# UNITED STATES PATENT AND TRADEMARK OFFICE

APPLICATION NO.	FILING DATE	FIRST NAMED INVENTOR	ATTORNEY DOCKET NO.	CONFIRMATION NO.
10/705,670	11/10/2003	Satoshi Mizutani	20050/0200468-US0	4676

<b>Office Action Summary</b>	Application No. 10/705,670	Applicant(s) MIZUTANI ET AL	
	Examiner Keshia Gibson	Art Unit 3761

## **DETAILED ACTION**

Fig. A: Original Figure 6 from prior art.

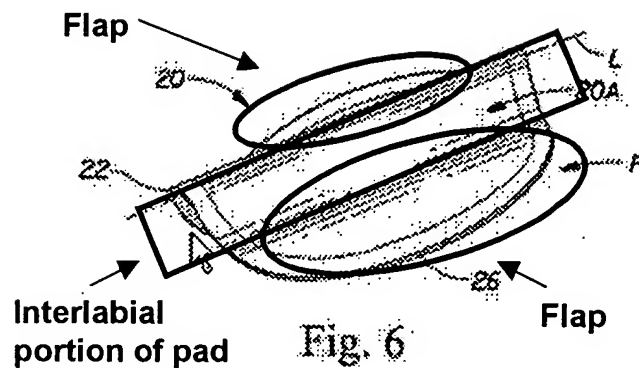
In regard to Claim 1, Osborn, III et al. disclose an interlabial pad having an absorbent pad body 32 (in area of pad marked interlabial portion of pad in Fig. B below) and a pair of flaps F (comprising surface side sheet and backside sheet) extending beyond each side of the pad body (Figs. A-C below; column 4, lines 20-30; column 14, lines 22-45). The pad body has a surface side sheet 28 and backside sheet 30 bonded together at peripheral edges to enclose the absorbent body (Fig. 1; column 4, lines 20-30). The flaps may be provided with an adhesive portion on the skin-contacting surface (Figs. A-C; column 5, lines 39-41; Figure 1; column 15, lines 44-59).

In regard to Claim 2, as seen in Fig. B above, the pair of flaps is provided at part or almost all parts of each side edge of both sides of the interlabial pad.

In regard to Claim 12, Osborn, III et al. disclose a longitudinal ridge along the centerline of the interlabial pad that forms the interlabial absorbent structure, thus the interlabial pad comprises a long convex area extending in a longitudinal direction on the body side sheet (Figure 6; column 14, lines 22-45).

Fig. C: Examiner's identification of flap and interlabial portions in relation to Fig. 1 of the prior art.

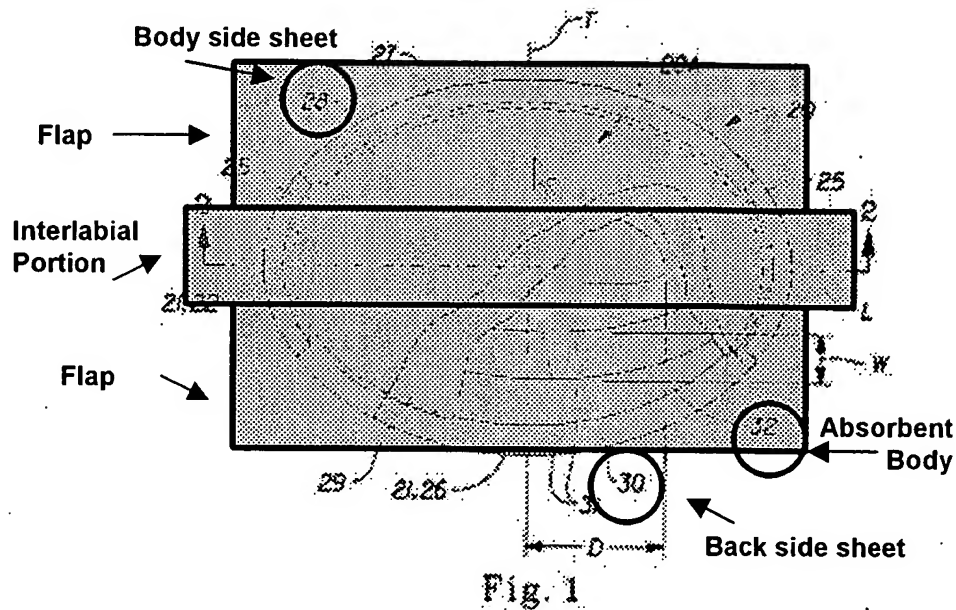
In regard to Claim 6, the interlabial pad comprises a water-permeable surface on the body side sheet **28** (column 11, lines 48-51; Figure 1) and a water-impermeable back side sheet **30** (column 8, lines 32-38; Figure 1). The body side sheet and the back side sheet have length and width dimensions greater than that of the absorbent core and are connected to each other (column 15, lines 60- column 16, line 44).

Thus, as can be seen in Figure C above, the flap portions are composed of equally extended parts of both the body side sheet and the back side sheet.

Fig. D: Examiner's markup of Lichstein's Fig. 17f .

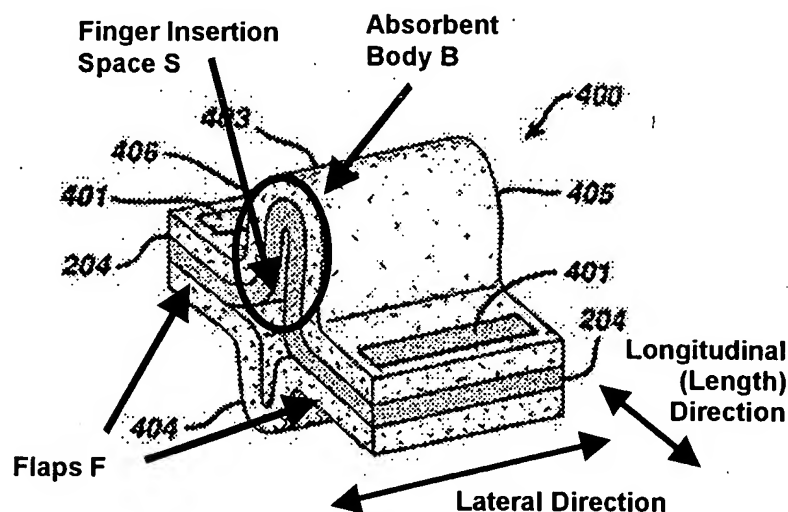
In regard to Claim 8, Lichstein discloses an interlabial pad 400 comprising an absorbent interlabial pad body B, a pair of flap portions F, an adhesive 401, and a minisheet piece 300 (Figs. 17a-f; Fig. D below). The minisheet 300 has a length longer than a lateral dimension of the absorbent body B and is attached to the body side face 201 by crossing the pad body B in the lateral direction (Figs. 17a-f; Fig. D below; page 9, line 33-page 10, line 23; page 8, lines 6-8). The flap portions F are formed by parts of the minisheet piece protruding from the side edges of the pad body B in a longitudinal direction (Fig. D; page 9, line 33-page 10, line 23).

In regard to Claim 9, the minisheet 300 forms a finger insertion opening S, which lies between the minisheet 300 and the opposite side face of the body side face 201 (Figs. 17a-f, Fig. D).

In regard to Claim 10, the minisheet 300 is water impermeable material (page 9, line 33- page 10, line 23).
